#### **Addendum 111 – UN Regulation No. 112**

#### **Revision 3 — Amendment 4**

#### **Uniform provisions concerning the approval of motor vehicle headlamps emitting an asymmetrical passing-beam or a driving-beam or both and equipped with filament lamps and/or light-emitting diode (LED) modules**

Figure 5: Class A for left-hand traffic only.

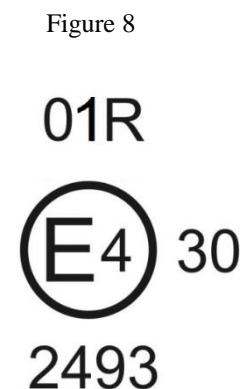
Annex 2, figures 5 to 10, amend to read:

The headlamp bearing the above approval mark is a headlamp incorporating a lens of plastic material meeting the requirements of this Regulation in respect of the passing-beam only and is designed:

"Figure B

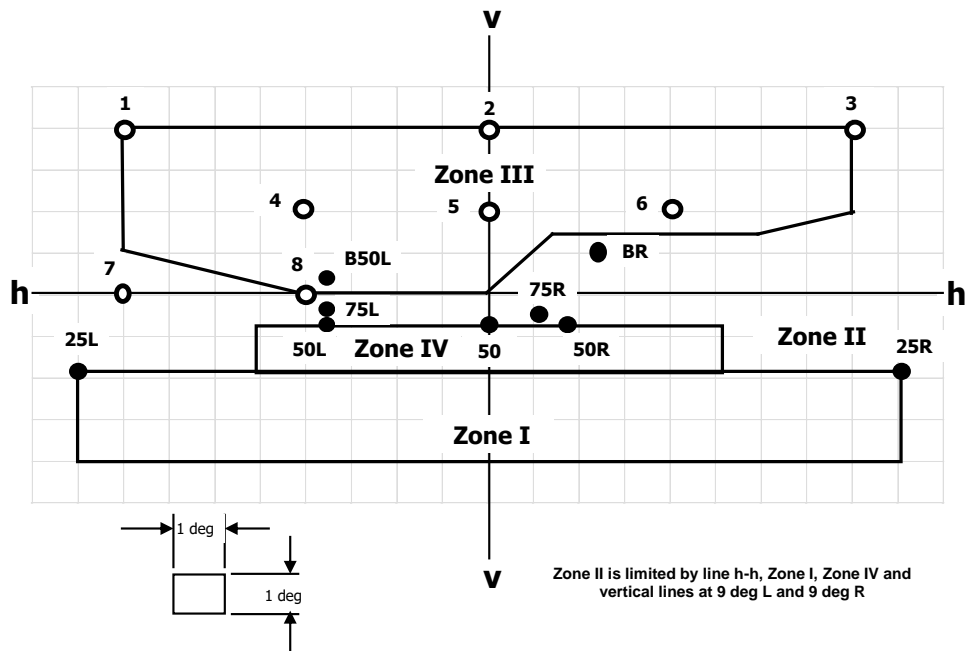
*Figure B*, amend to read:

h-h = horizontal plane , v-v = vertical plane passing through the optical axis of the headlamp  
 The test point locations for left-hand traffic are mirrored about the VV line."
